Project	IEEE 802.16 Broadband Wireless Access Working Group < http://ieee802.org/16 >	
Title	Enhancement Feature for Robust Multimedia Broadcasting	
Date Submitted	[2004-07-07]	
Source(s)	<p>Jungje Son Jaeweon Cho Panyuh Joo Beomsik Bae Yong Chang</p> <p>Samsung Electronics 416, Maetan-3dong, Youngtong-gu Suwon-si, Gyeonggi-do Korea</p>	<p>Voice: +82-31-279-5098 Fax: +82-31-279-5130</p> <p>jungje.son@samsung.com jaeweon.cho@samsung.com panyuh@samsung.com bsbae@samsung.com yongchang@samsung.com</p>
Re:	This contribution is for reply of IEEE P802.16e/D3 recirculation.	
Abstract	This contribution proposes the physical enhancement feature for robust multimedia broadcasting service.	
Purpose	Discussion and Adoption in IEEE 802.16e	
Notice	This document has been prepared to assist IEEE 802.16. It is offered as a basis for discussion and is not binding on the contributing individual(s) or organization(s). The material in this document is subject to change in form and content after further study. The contributor(s) reserve(s) the right to add, amend or withdraw material contained herein.

Enhancement Feature for Robust Multimedia Broadcasting

Jungje Son, Jaeweon Cho, Panyuh Joo, Beomsik B

Figure 14. Time multiplexing for OFDMA The multi-subpacket transmission scheme

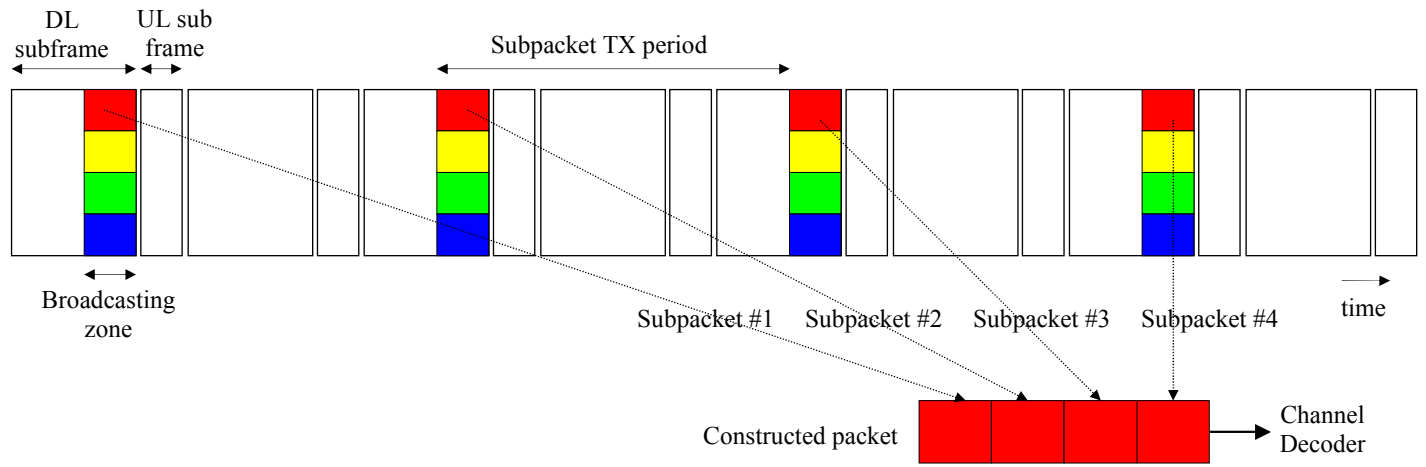
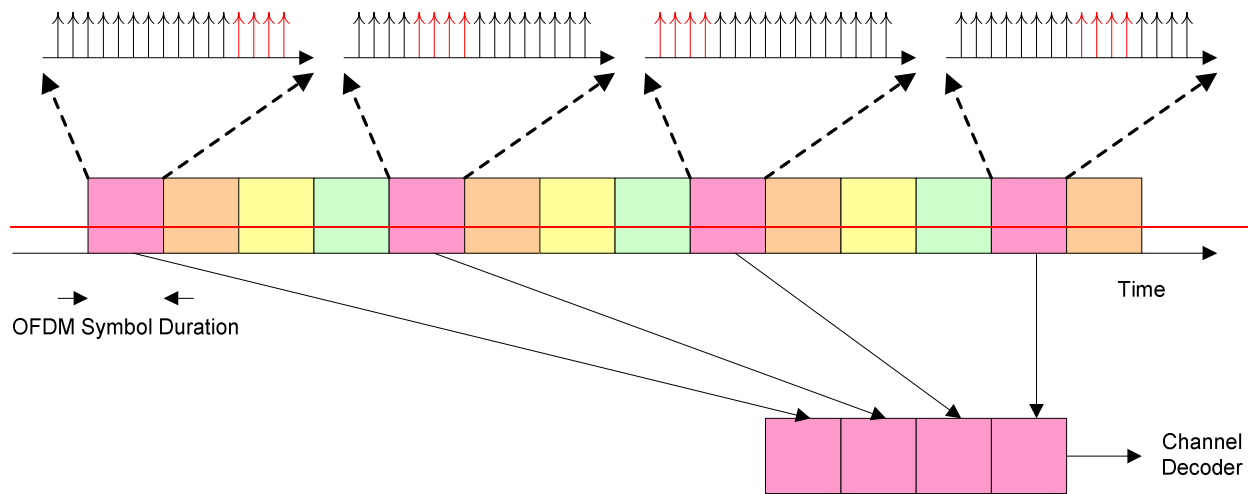
In this contribution, ~~as shown in figure 1,~~ we propose the ~~way~~ BS transmission scheme of ~~t~~ multimedia broadcasting traffic ~~to exploit~~ time diversity. ~~In the proposed scheme, the encoded packet is divided into multiple subpackets and each subpacket is transmitted in different frame so as to go through different fading channel. MS collects and concatenates these subpackets, and then the constructed packet is decoded at the channel decoder.~~ Figure 1 depicts the proposed multi-subpacket transmission scheme. The example shown in this figure is for the case that the packet is divided into 4 subpackets and the transmission period of subpacket is 2 frames. ~~Time multiplexing is the scheme that divides the coded symbols from encoder into multiple symbols and transmits each during discontinuous time interval.~~

To support ~~time multiplexing as shown in figure 1~~ the proposed multi-subpacket transmission scheme, we should make another DL-MAP_IE.
